Project	IEEE 802.16 Broadband Wireless Access Working Group < http://ieee802.org/16 >	
Title	Frame Structure to Support Out-of-Band Relay	
Date Submitted	2007-01-08	
Source(s)	Wendy C Wong wendy.c.wong@intel.com Jerry Sydir jerry.sydir@intel.com Kerstin Johnsson Hannah Hyunjeong Lee	Intel Corporation 2200 Mission College Blvd., Santa Clara, CA 95054, USA
Re:	This is a response to the call for proposals 80216j-06_034.pdf.	
Abstract	This contribution propose a frame structure to support out-of-band multi-hop (≥ 2 hop) relay operation.	
Purpose	Text proposal for 802.16j Baseline Document.	
Notice	This document has been prepared to assist IEEE 802.16. It is offered as a basis for discussion and is not binding on the contributing individual(s) or organization(s). The material in this document is subject to change in form and content after further study. The contributor(s) reserve(s) the right to add, amend or withdraw material contained herein.

Frame Structure Support Out-of-Band Relay

Figure xxx Example of $M-1$ frame MR-BS and RS Super-Frame k for out-of-band relay

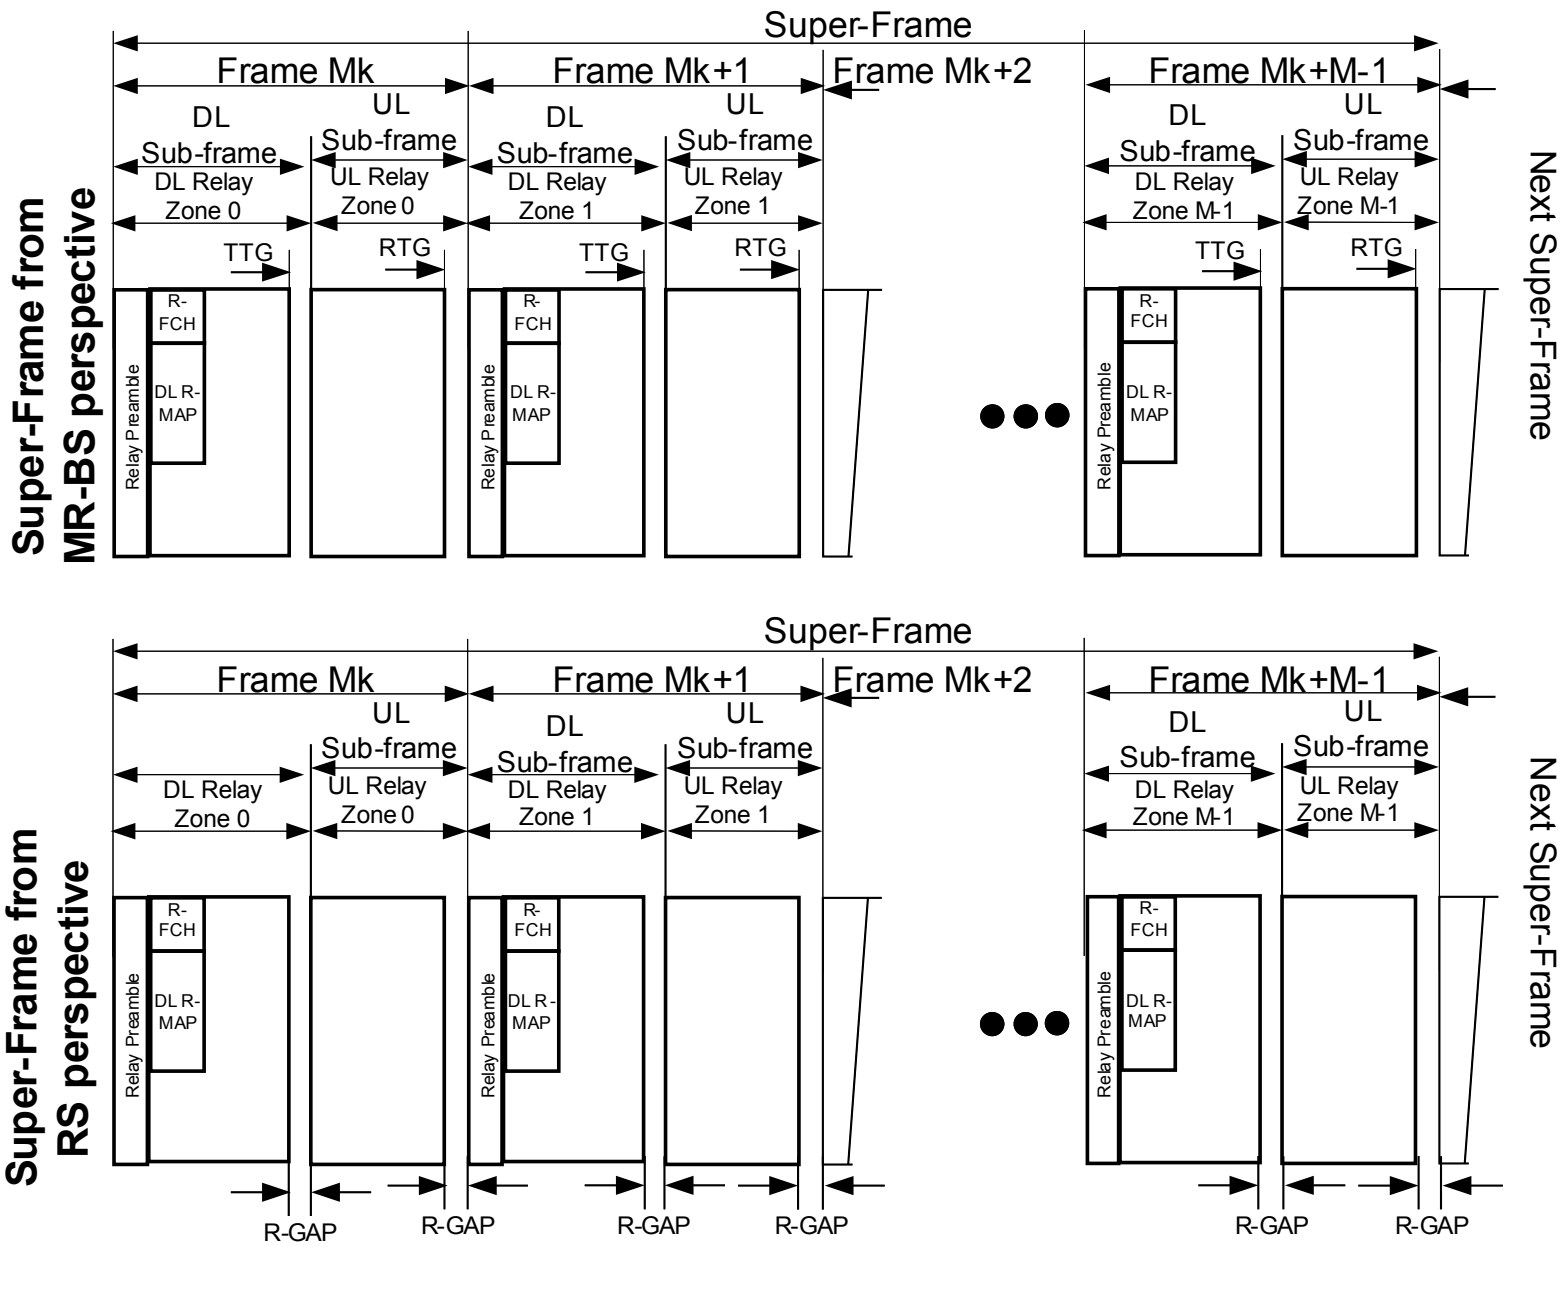
[Insert section 8.4.4.7.2.4 at the end of section 8.4.4.7.2.3]

8.4.4.7.2.4 Super-frame structure to support out-of-band multi-hop relay (≥ 2 hops)

The super-frame structure for out-of-band relay can be found in Figure xxx. A super-frame is defined to be a set of consecutive frames and the number of frames in a super-frame is configurable. The MR-BS and RSs can participate in 1 or more Relay_Zones to transmit and receive depending on the deployment scenarios and network assignments. An RS can switch between being a parent RS and a child RS among the frames within a super-frame. However, during each frame within the super-frame structure, an RS can be either a parent RS or a child RS but not both.

Each frame within a super-frame is divided into a DL Relay_Zone and a UL Relay_Zone.

The DL Relay_Zone within each MR-BS super-frame starts with a relay preamble, followed by R-FCH, R-MAP. During a DL Relay_Zone of a frame within the MR-BS super-frame structure, the MR-BS transmits to its child RSs. During a UL Relay_Zone of a frame within the MR-BS super-frame structure, child RSs transmit to the MR-BS who has transmitted to the child RSs in the earlier DL Relay_Zone of the same frame within the MR-BS super-frame structure.

A TTG shall be inserted between each DL Relay_Zone and UL Relay_Zone within each frame in the MR-BS super-frame. A RTG shall be inserted at the end of each frame in the MR-BS super-frame.

The DL Relay_Zone within each RS super-frame starts with a relay preamble, followed by R-FCH, R-MAP. During a DL Relay_Zone of a frame within the RS super-frame structure, a parent RS transmits to its child RSs. During a UL Relay_Zone of a frame within the RS super-frame structure, child RSs transmit to its parent RS who have transmitted to the child RSs in the earlier DL Relay_Zone of the same frame within the RS super-frame structure.

An R-GAP shall be inserted between each DL Relay_Zone and UL Relay_Zone and between each frame within the RS super-frame structure.
